Alameda Point Adaptive Reuse Street Sections

Proposed updates to
the Master Infrastructure Plan

January 23, 2019

Proposed Changes to Bike Facilities

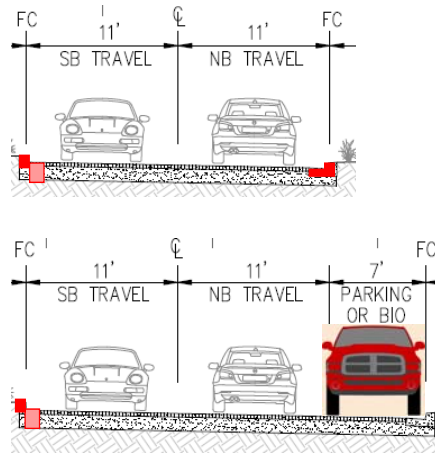
1. Seaplane Lane: upgrade bike lanes to 2-way cycle track
2. Tower Ave: convert hybrid facility to Class 2 bike lanes
3. Pan Am Way: convert hybrid to 1-way cycle tracks
4. Orion Street: extend Site A 1-way cycle tracks to the north

Proposed Changes to Lane Widths

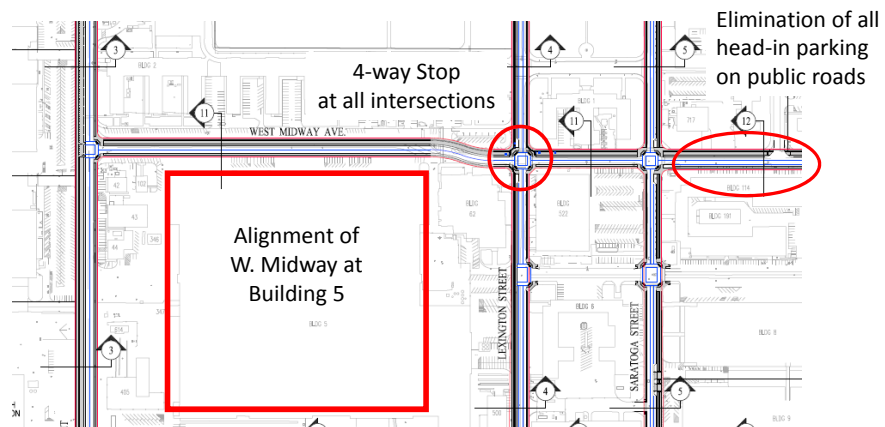
- Maintain 10 foot nominal travel lane width in Adaptive Reuse Area
- AASHTO lane with definition: Does Not Include Gutter or 1 foot width next to curb
- 10 foot effective lane width next to on street parking
- Full Size Pickup Trucks exceed 7 feet wide at mirrors

W. Redline Ave

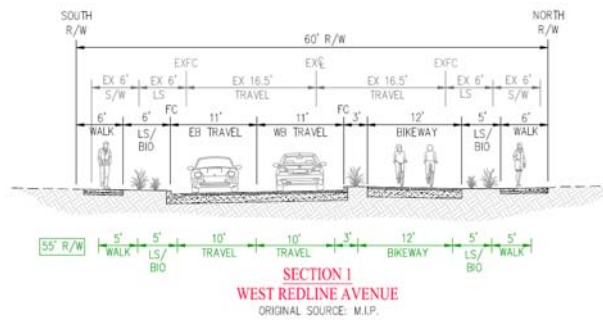
- Widen travel lanes to 11ft
- Widen sidewalk to 6ft

Monarch Street

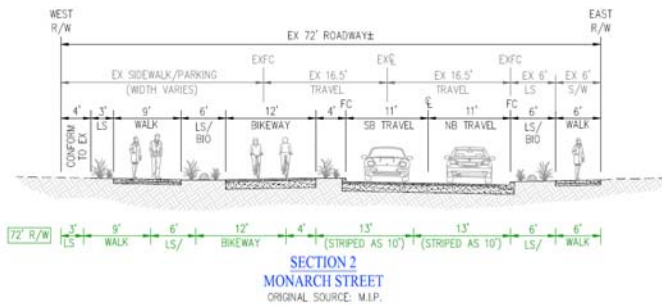
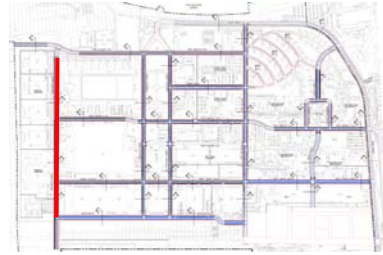
- Reduce lane widths to 11 ft

Lexington Street

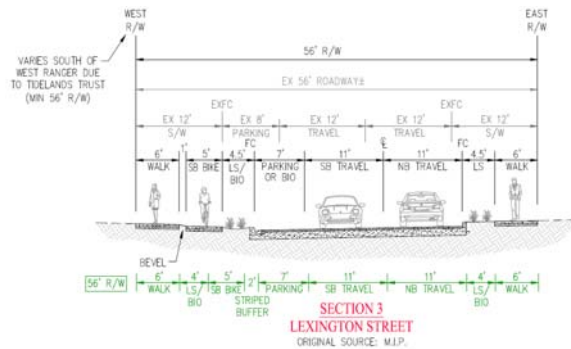
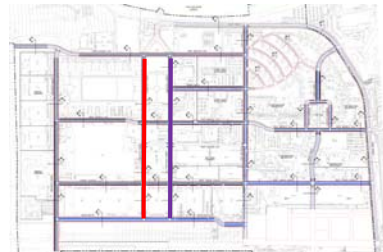
- Move 1-way cycle track adjacent to walk
- Similar change to Saratoga Ave

Pan Am Way

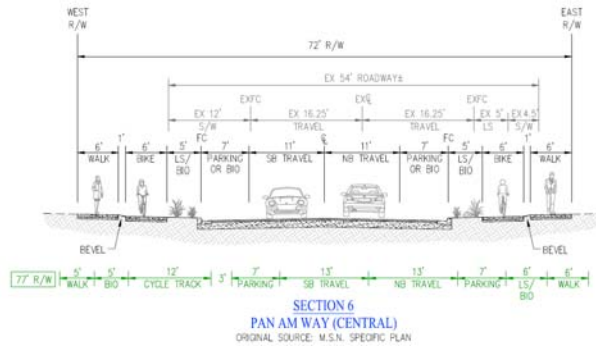
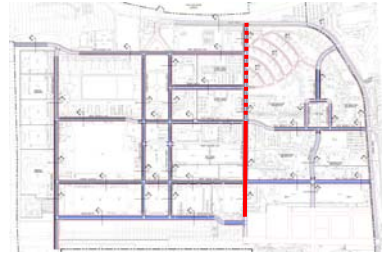
- 1-Way cycle tracks
- May need to be modified with West Midway Development
- Section north of Midway to be finalized with Main St Neighborhood

W. Midway Ave

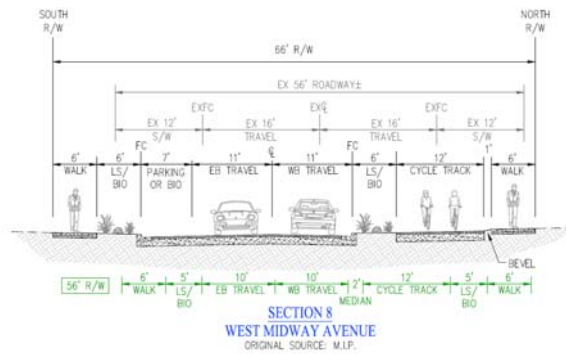
- Widen lanes to 11ft
- Add parking opposite of cycle track
- Shift roadway away from Bldg 5
- Section East Pan Am to be finalized with West Midway Development

W. Tower

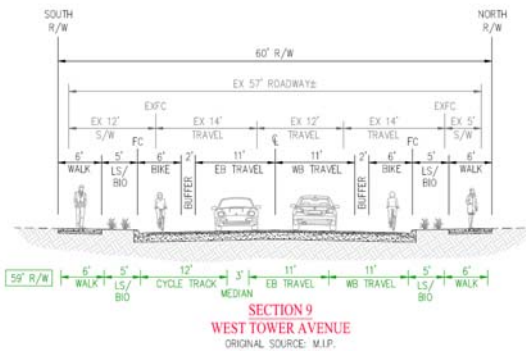
- Class 2 bike lanes for full length
- Shift Cycle Track to Seaplane
- Section East of Pan Am finalized as part of Site A Phase 2 Development

Seaplane

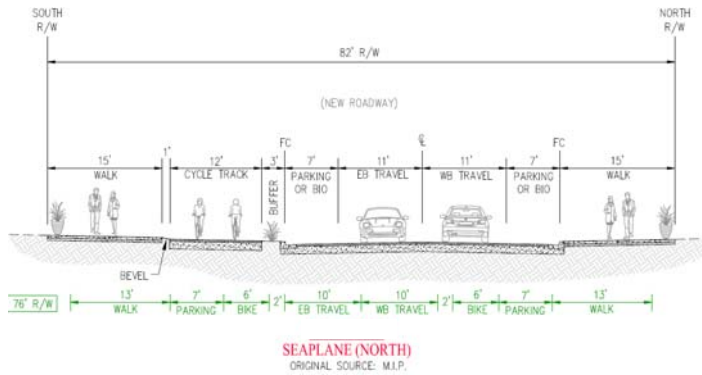
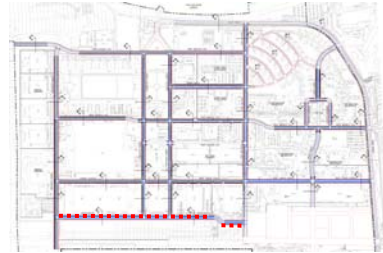
- Cycle track on lagoon side of roadway
- Not a Part of Adaptive Reuse Project
